# HISTORIC AND DESIGN REVIEW COMMISSION

**HDRC CASE NO:** 2017-248  
**COMMON NAME:** St John's Seminary  
**ADDRESS:** 222 E MITCHELL ST  
**LEGAL DESCRIPTION:** NCB 3975 BLK 1 LOT 1-4,6-10,17- 21,29, N IRR PT 4 OF A29,A-31A, P-100 & ADJ 16' STRIP  
**ZONING:** MF-33 H, MPOD,  
**CITY COUNCIL DIST.:** 3  
**DISTRICT:** Mission Historic District  
**APPLICANT:** Mark Tolley/Mission DG, LTD  
**OWNER:** Archdiocese of San Antonio  
**TYPE OF WORK:** Amendment to a previously approved design regarding roof design, foundation heights, building footprints, site design, site parking and building elevations

The applicant is requesting a Certificate of Appropriateness for approval to amend a previously approved design to include modified roof design, foundation heights, modified site designs, the relocation of the swimming pool, site parking, the elimination of one structure and façade modifications to include a redesign of structures G and F.

01 ROOF PLAN  
BUILDING TYPE I - ROOF PLAN  
SC 3/32" = 1'-0"

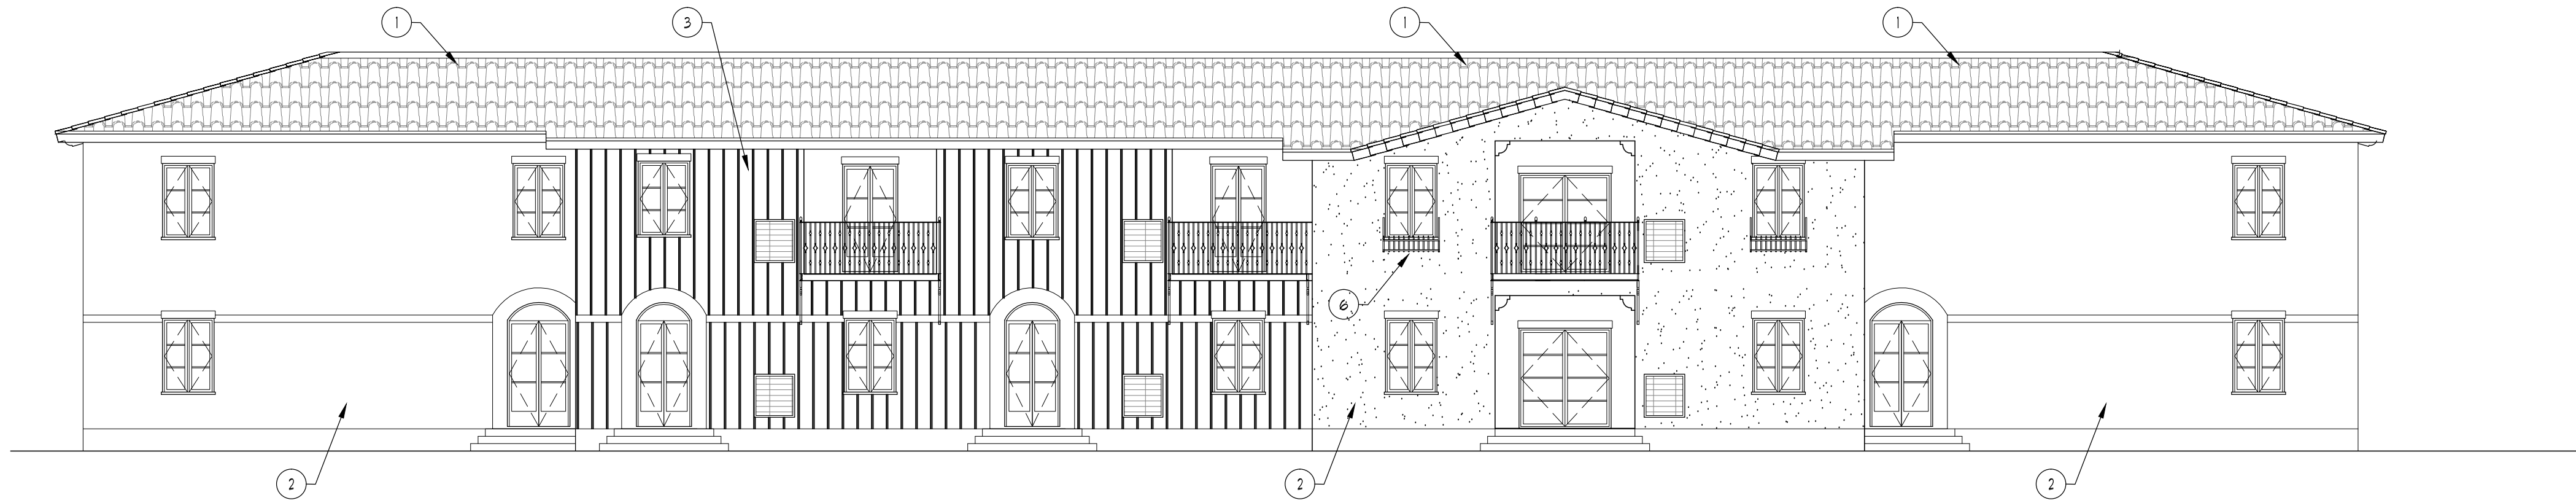
RETAIN SLOPED ROOFS (MIN. 4:12 SLOPE) WITH COMPOSITE BARREL TILE (AS PREVIOUSLY APPROVED) AT SINGLE-LOADED WINGS AND UTILIZE A MANSARD STYLE ROOF (TPO FLAT ROOF AT INNER AREA) CONFIGURATION AT DOUBLE-LOADED CORRIDORS TO LIMIT OVERALL BUILDING HEIGHT

01 EXTERIOR ELEVATION  
BUILDING TYPE I - NORTH @ BLDG #1  
SC: 1/8" = 1'-0"

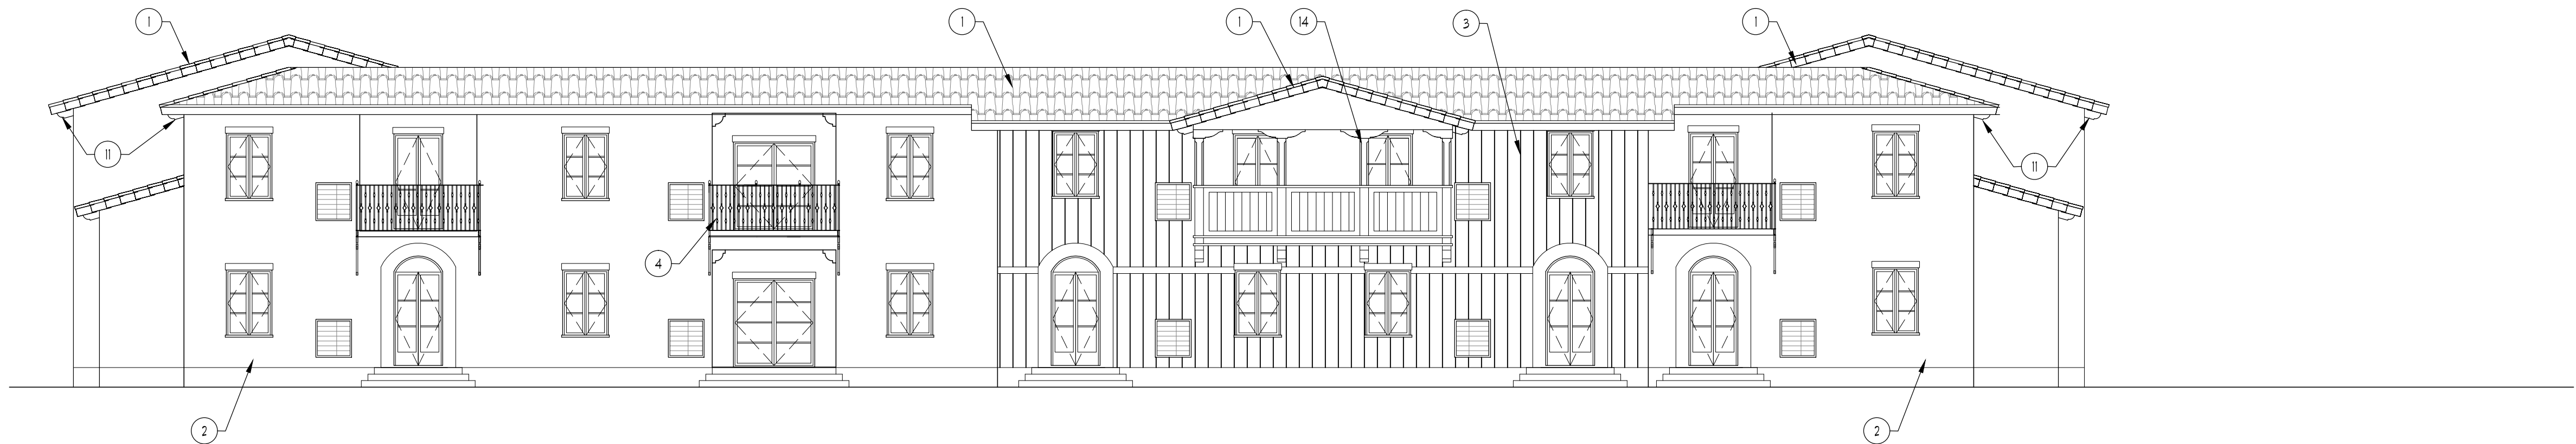
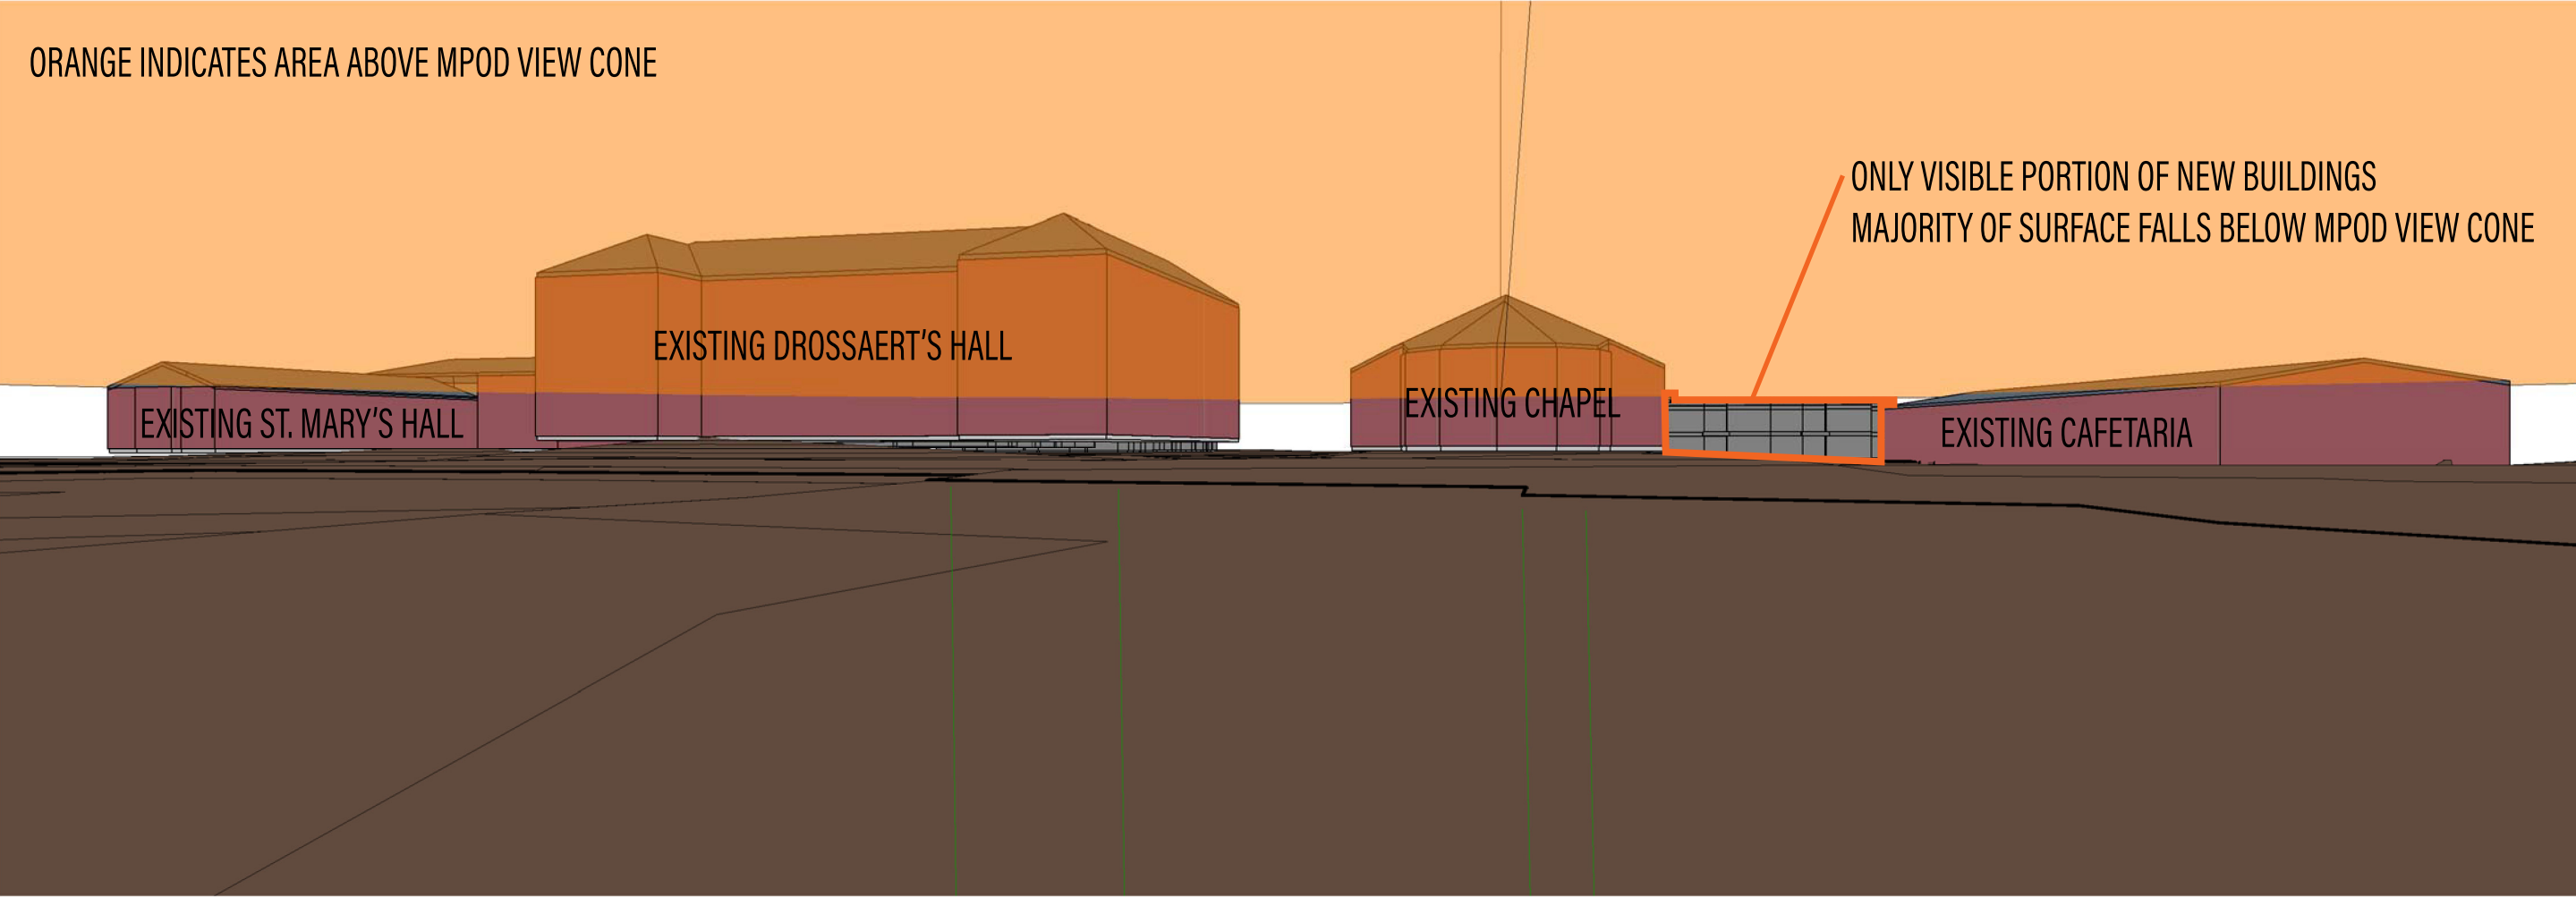
RETAIN ARCHED OPENINGS AT SINGLE  
DOORS OR BREEZEWAY OPENINGS.

RE-INTRODUCE CASEMENT WINDOWS  
WHERE APPROPRIATE IN LIEU OF  
PREVIOUSLY APPROVED 3-OVER-1  
SINGLE HUNG WINDOWS.

8" TYPICAL ELEVATION FROM GROUND  
TO FINISHED FLOOR AT FIRST LEVEL.

9'-0" PLATE HEIGHTS PER LEVEL AS IS  
TYPICAL FOR NEW CONSTRUCTION.
